TOLEDO - LUCAS COUNTY PLAN COMMISSIONS

REF: SUP-9001-23

TO: President Carrie Hartman and Members of Council, City of Toledo
FROM: Toledo City Plan Commission, Thomas C. Gibbons, Secretary
SUBJECT: Special Use Permit for a Day Care Center at 1119 W Bancroft Street

SITE PLAN

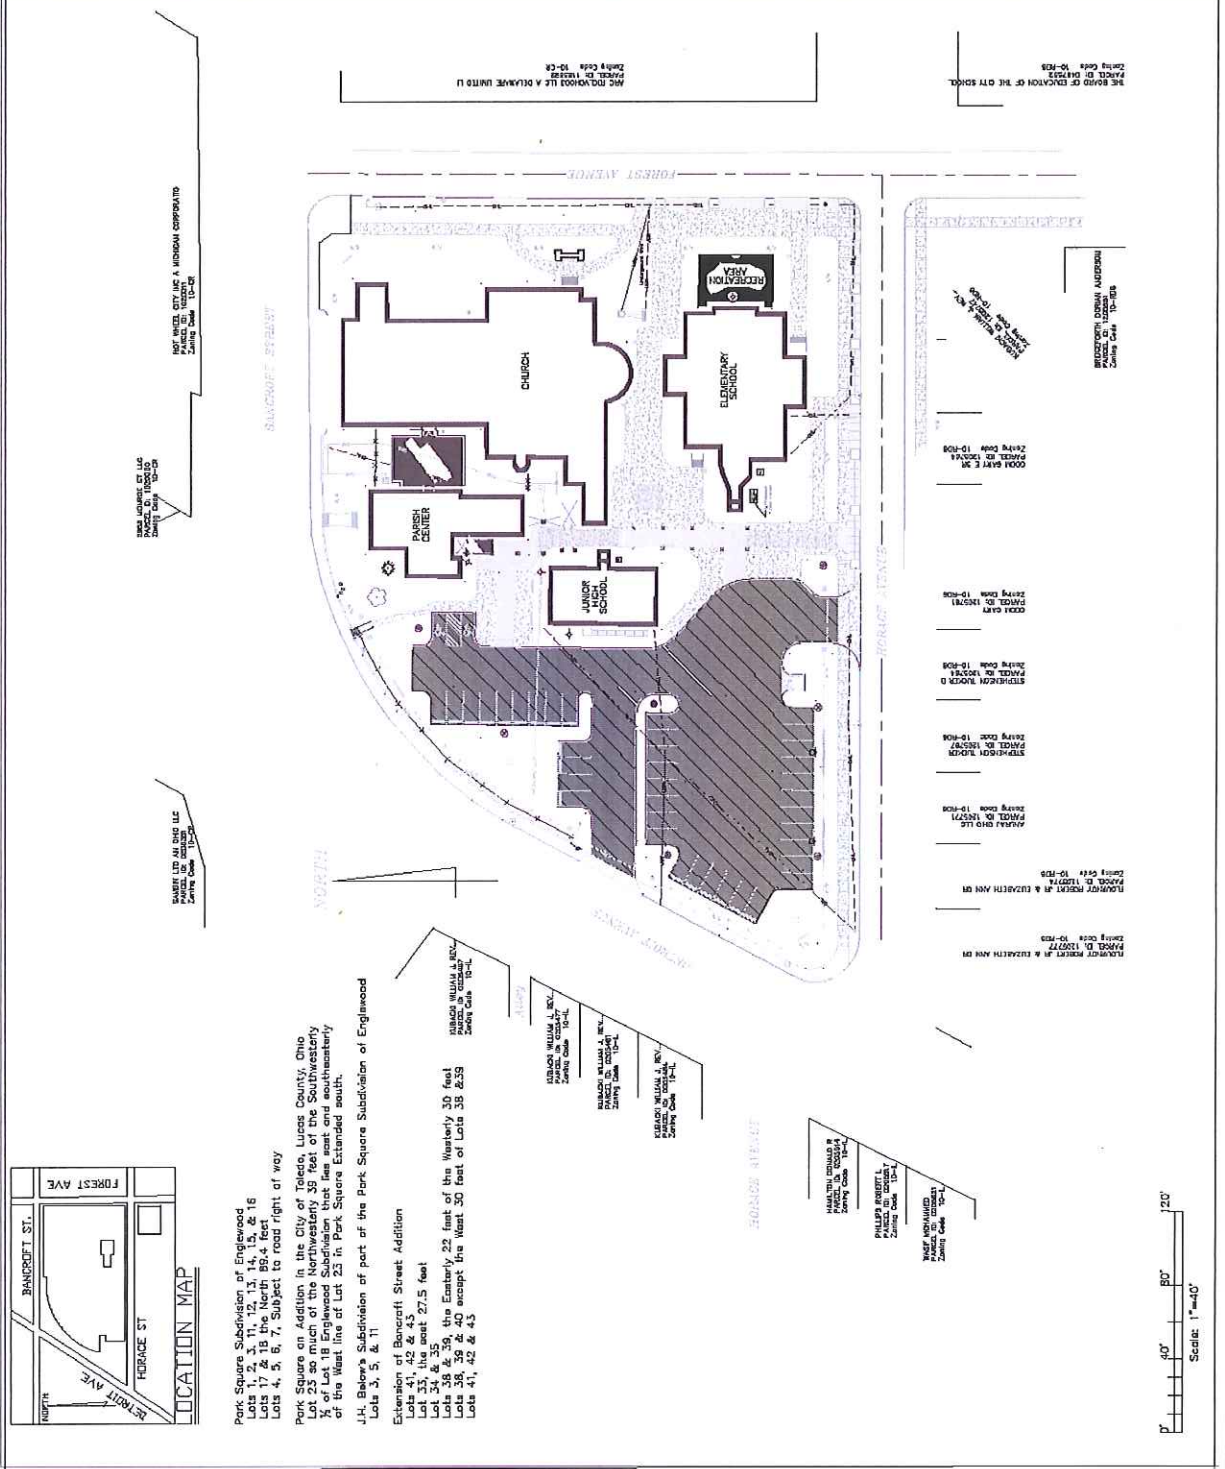
18. Per TMC§1104.0703(E) a Day Care Center is required to provide 60 square feet of useable outdoor space for each person in their care using the outdoor space at any one time. The site plan depicts a fenced outdoor area that is approximately 600 square feet in area that is enclosed by a 42 inch high galvanized chain link fence around the north, south and east perimeter. An existing building wall will act as the west boundary. A five foot wide gate is proposed on the north side of the outdoor area with a six foot wide concrete walk from the fence to an existing sidewalk. **Acceptable as depicted.**

21. Per the Off-Street Parking Schedule in TMC§1107.0304 a day care center is required to provide 1 bicycle space for every 10 parking spaces; or per TMC§1107.0901(B) a minimum of two bicycle parking slots shall be provided when the provision for bicycle parking slots is required. The site plan depicts two bicycle racks. **Acceptable as depicted.**

- a. Per TMC§1104.0703(E) a Type B landscape buffer is required around the outdoor space in accordance with TMC§1108.0203(F). This section requires a landscape buffer of 10 feet in width with three canopy trees and 11 shrubs to be installed for the proposed 70 foot outdoor area perimeter. The site plan depicts a 42 inch high galvanized chain link fence with a 10 foot wide landscape buffer on the east and a 15 foot wide buffer on the north and south containing 15 shrubs and two trees. Four existing trees are also located within the buffer area. **Acceptable as depicted.**

- b. The location of the proposed outdoor area is currently heavily shaded by the four existing trees. The two proposed trees shall be installed to the south of the outdoor area, in the grass area between the internal site sidewalk and the street sidewalk, or elsewhere on the site as approved by the Plan Director.

23. Four copies of a revised site, fencing and landscaping plan (separate from building & site plans) shall be submitted to the Plan Director for review and approval. Such plan shall include:
